DS-K5671 Series MinMoe Terminal Release Notes (2021-11-15)

Device Model: DS-K5671-ZV/ZH/ZU	Firmware Version	ARM: ACS_671_AI3_EN_STD_V3.2.0_build211110 ACS_671_AI3_EN_NEU_V3.2.0_build211110
	SDK	Latest version
	iVMS-4200 Version	Latest baseline

DS-K5671 Series MinMoe Terminal Release Notes (2021-02-08)

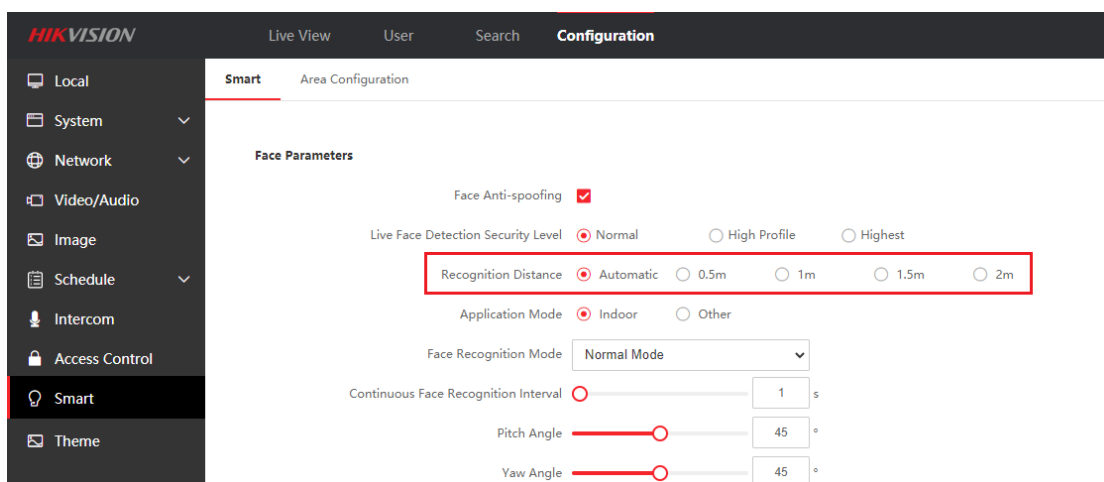
1. Optimize the wake-up distance of the device screen through the face, and the wake-up distance is consistent with the recognition distance

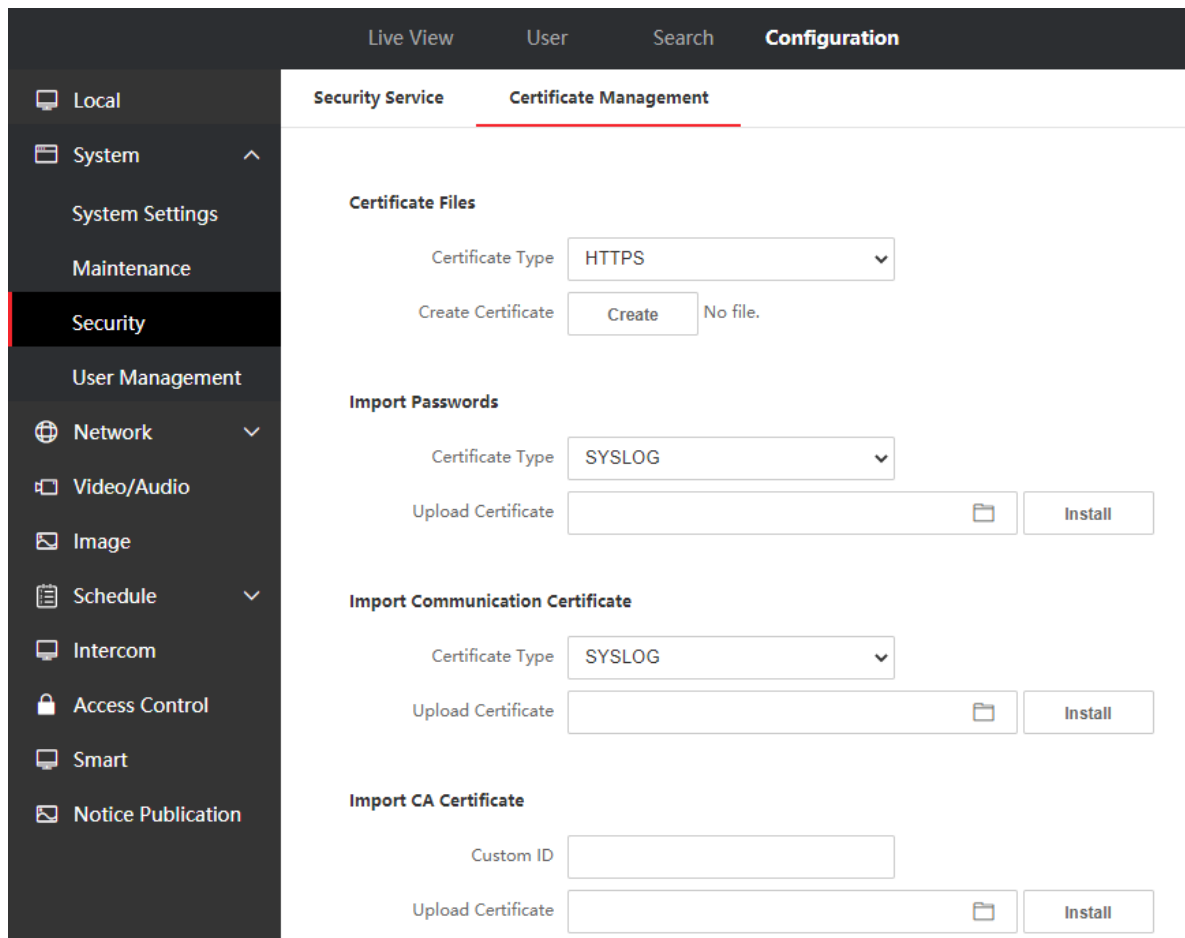
1. Support https feature

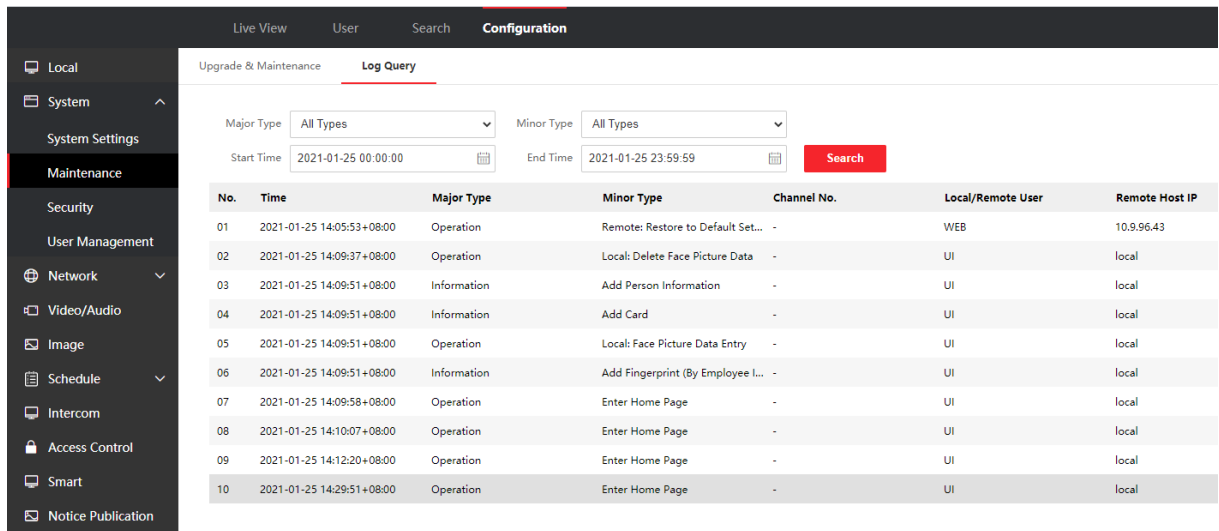
5. Add device operation log query function

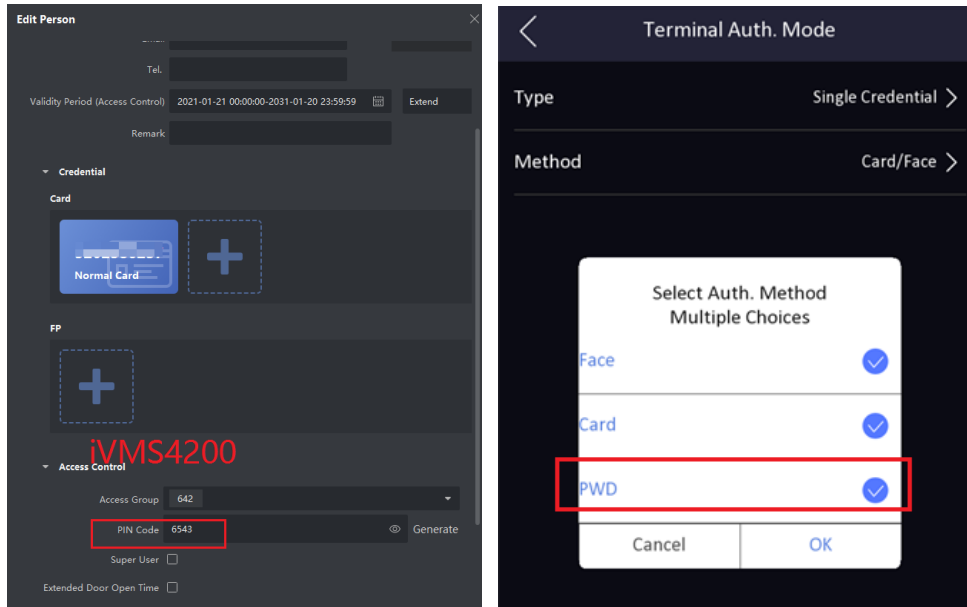
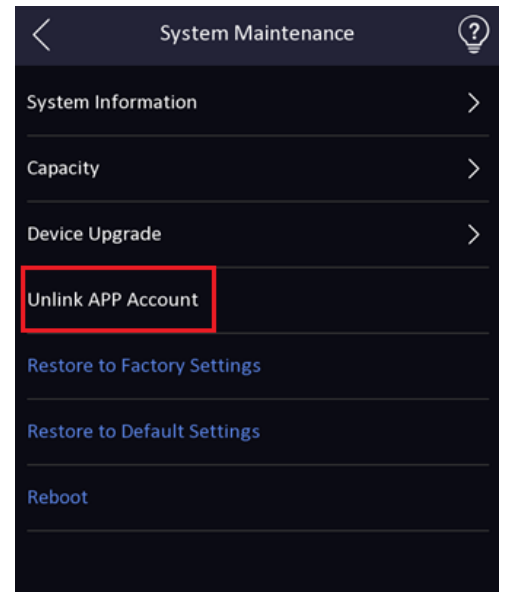
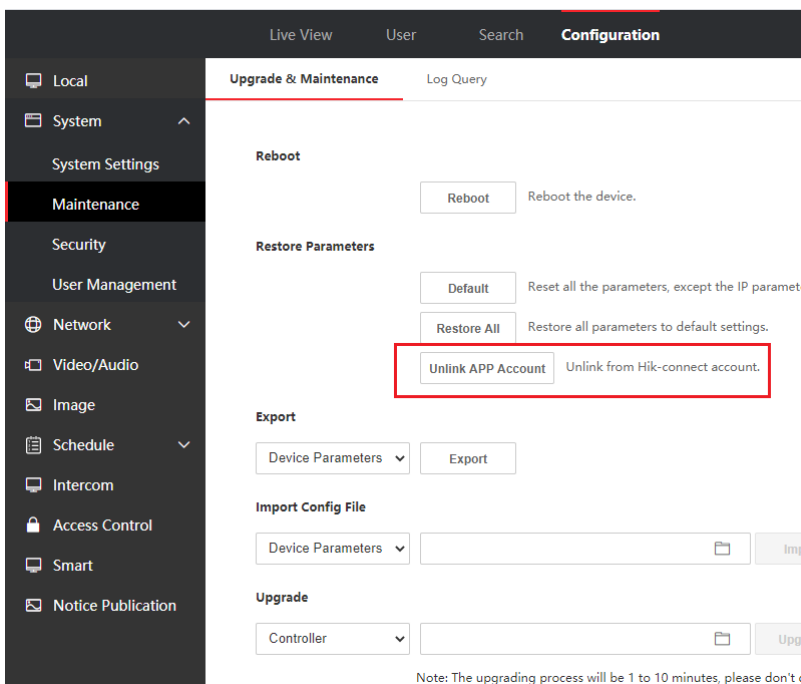
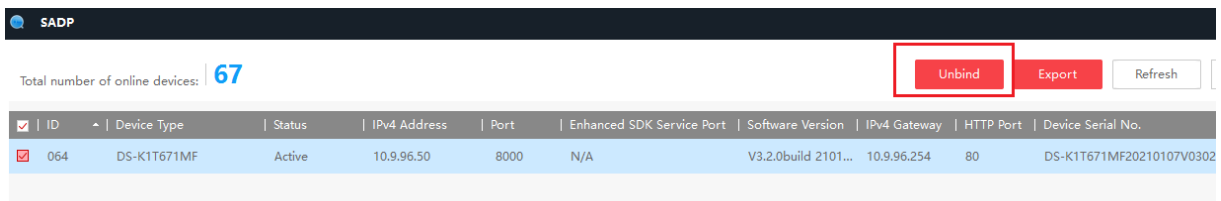
7. Support PIN code to open the door (disabled in default)

Note: PIN code should be configured from software, iVMS4200 already support, HikCentral Pro will support PIN code configuration in V2.1 expected to be released in June

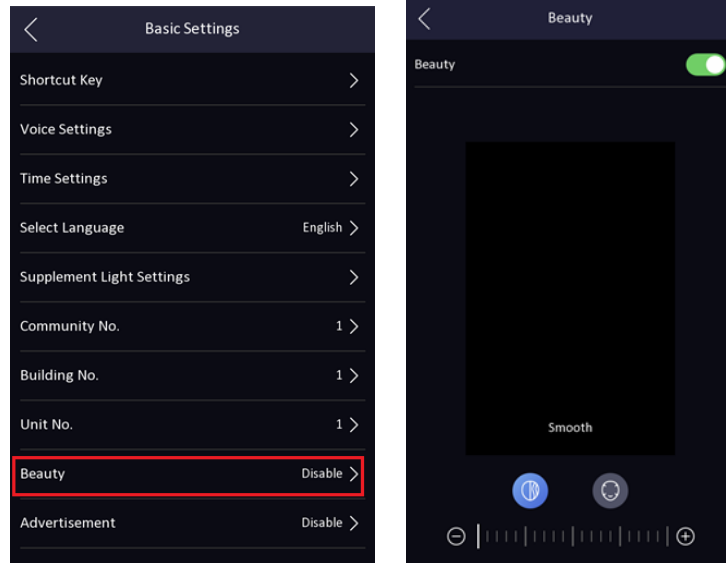
8. Support unbind device with hik-connect account on SADP tool, local UI and web interface

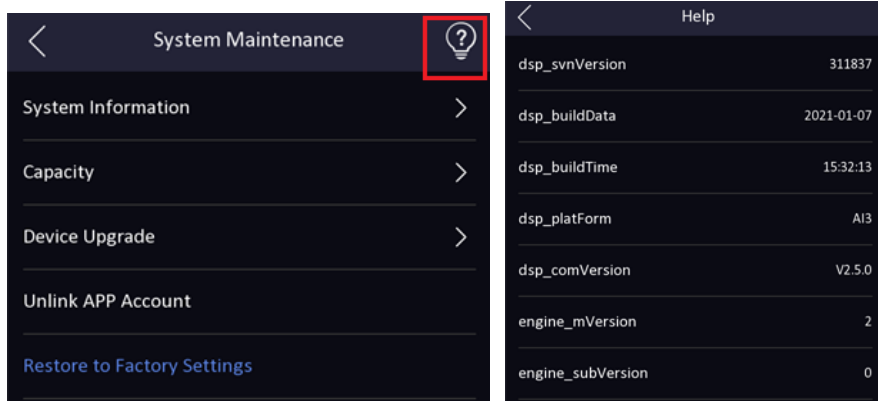
9. Add beauty function to adjust smooth and whiten parameter.

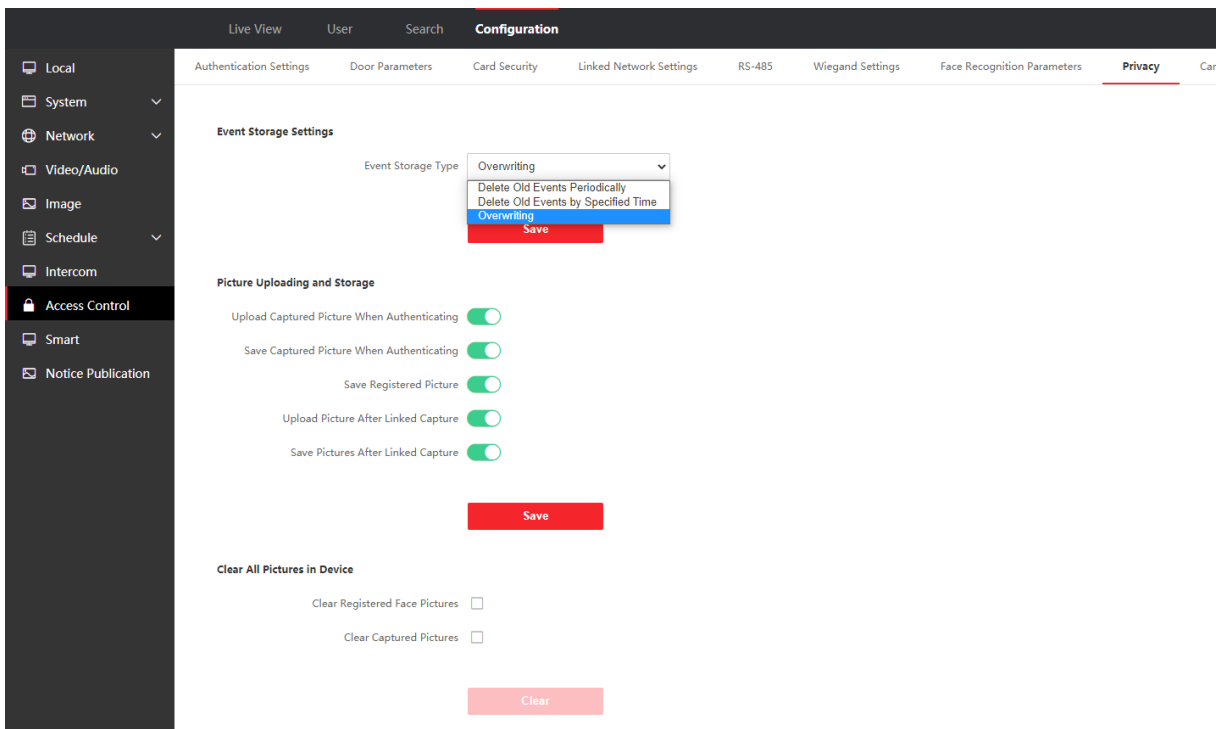
10. Add help interface to check system module version for technical support (long press for 3s).

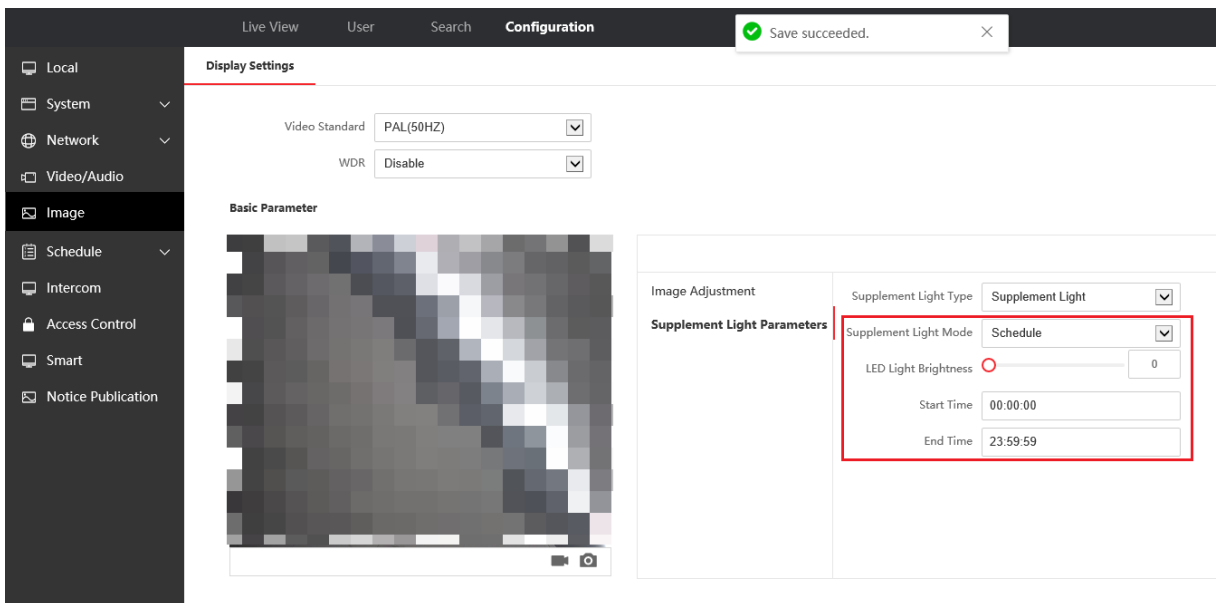
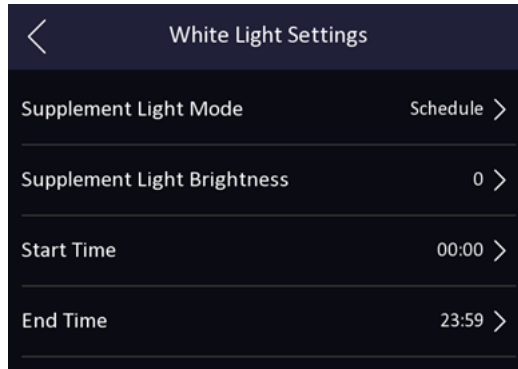
11. Add privacy protection, customer can define the privacy related parameter, such as Event Storage Settings, Picture Uploading and Storage, Clear All Pictures in Device

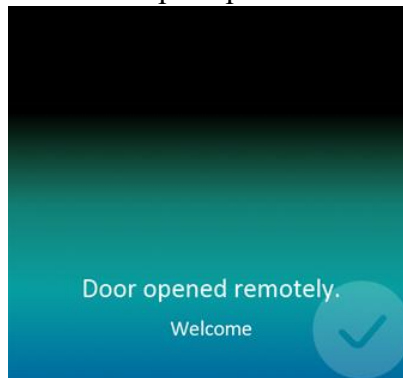
12. Configure the time period when the white light fill light is turned on and off in device local menu or web interface

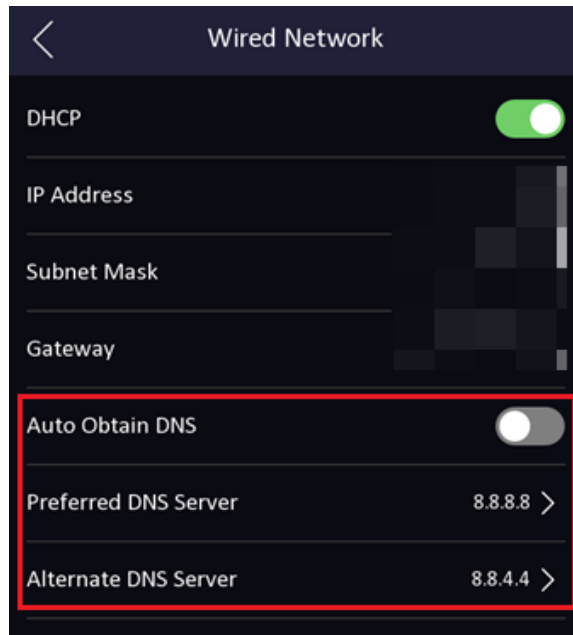
3. Hik-Connect function is turned off in default for privacy protection, if customer want to manage device from App, please turn on manually in the web.

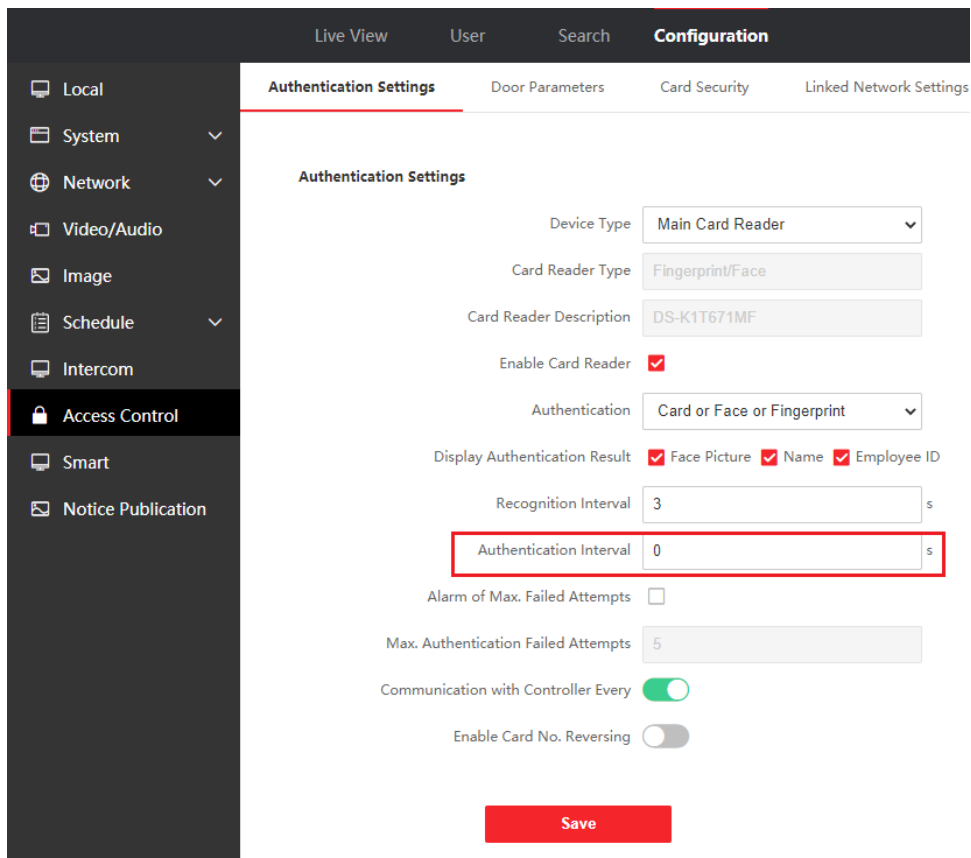
- 4. The face matching algorithm is upgraded. Improve the speed and accuracy of face recognition. Improved the recognition effect of dark masks
- 5. DNS can be configured from device UI in menu → Comm.-->Wired Network

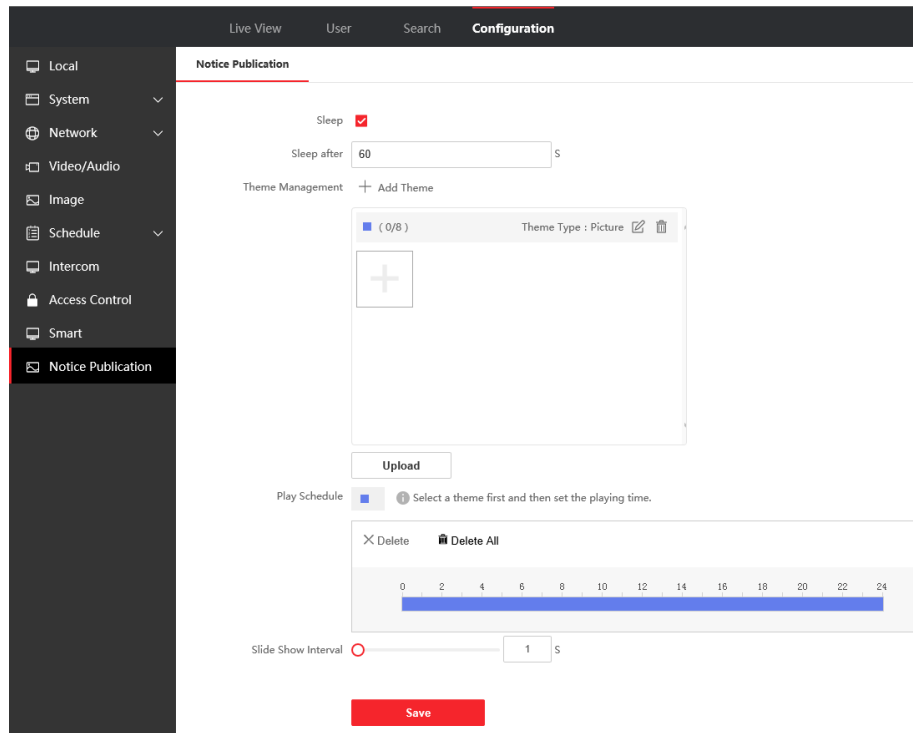
- 6. Optimized the ISUP and Hik-Connect event upload mechanism.
- 7. Add stranger authentication timeout time configuration
